This letter presents revisions to the January 13, 2012 Remedial Investigation Workplan (RI Workplan) prepared on behalf of PCC Flow Technologies (PCC) by The Source Group (SGI) for the former PACO Pumps facility located at 9201 San Leandro Street in Oakland, California (the Site, Figure 1).

REVISED PROPOSED MONITORING WELL AND SUB-SLAB VAPOR POINT LOCATIONS

9201 SAN LEANDRO STREET
OAKLAND, CALIFORNIA

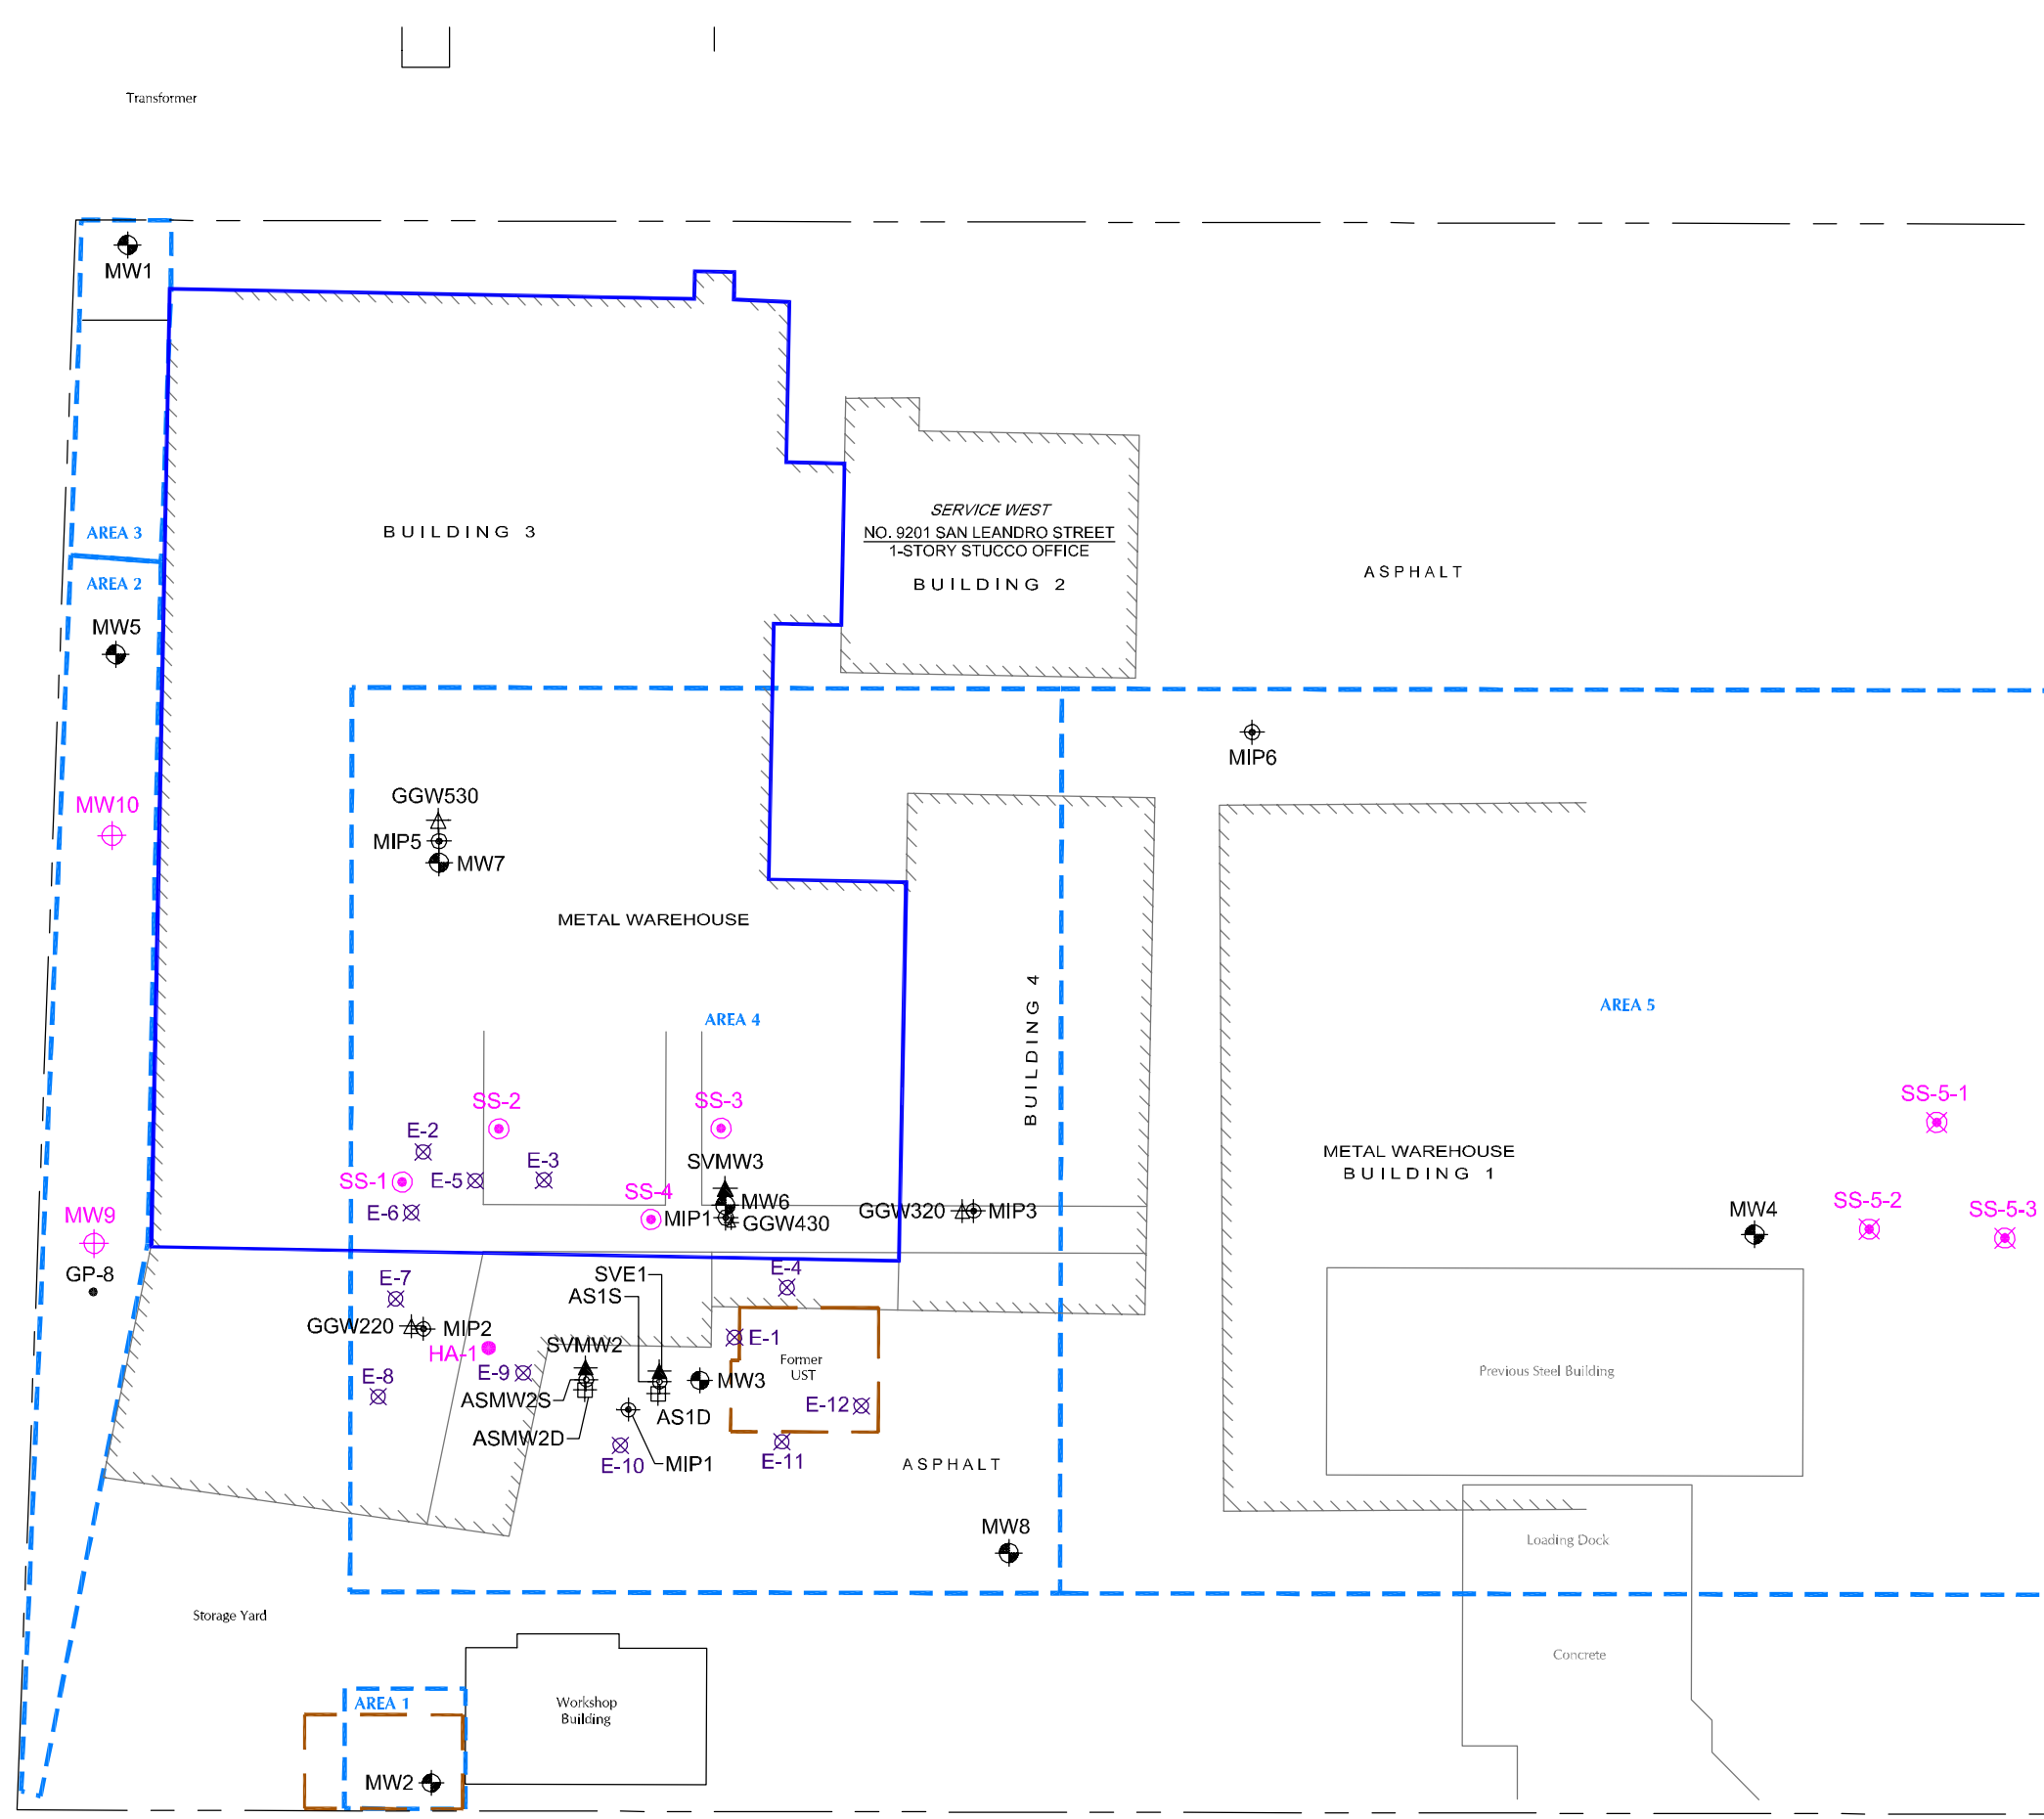
In early 2012, the eastern and southern edges of Building 3 were modified by the building operator, and the eastern and southern parts of Building 3 are now no longer covered (See Figure 2). The previous sub-slab sampling in that area has therefore been removed from the sub-slab investigation scope.

The proposed sub-slab investigation includes 4 locations in the southern part of building 3. During the proposed installation of locations SS-1 / SS-2 and HA-1, (near locations E-3 / E-5 noted by ACEH), hand augering to 8-9 feet below grade will also be conducted and 2 to 3 soil samples per location will be collected for analysis for TPHd and TPHMo and VOCs. The hand augered holes will be backfilled with neat cement to the depth equivalent to the other sub slab probes.

Additionally, as requested by ACEH, 3 sub slab soil gas locations will also be installed and tested in Area 5, east of MW-4.

Per ACEH request, additional soil sampling will be conducted at one hand-auger location (HA-1) near existing shallow wells E-9, for soil sampling, with sampling and analysis (for TPHd, TPHMo

In addition to the proposed monitoring well MW-9, one additional well (MW-10) is proposed. Drilling of both wells will include continuous coring from a depth of 5 feet below grade to groundwater (after 5 feet of hand-augering), and at each location a monitoring well will be constructed to intersect the upper surface of ground with a maximum 5 ft. long screen interval. Two to three soil samples will be collected for analysis during the well installation. The monitoring wells will be surveyed, and added to the site-wide groundwater monitoring program and associated Geotracker filing.
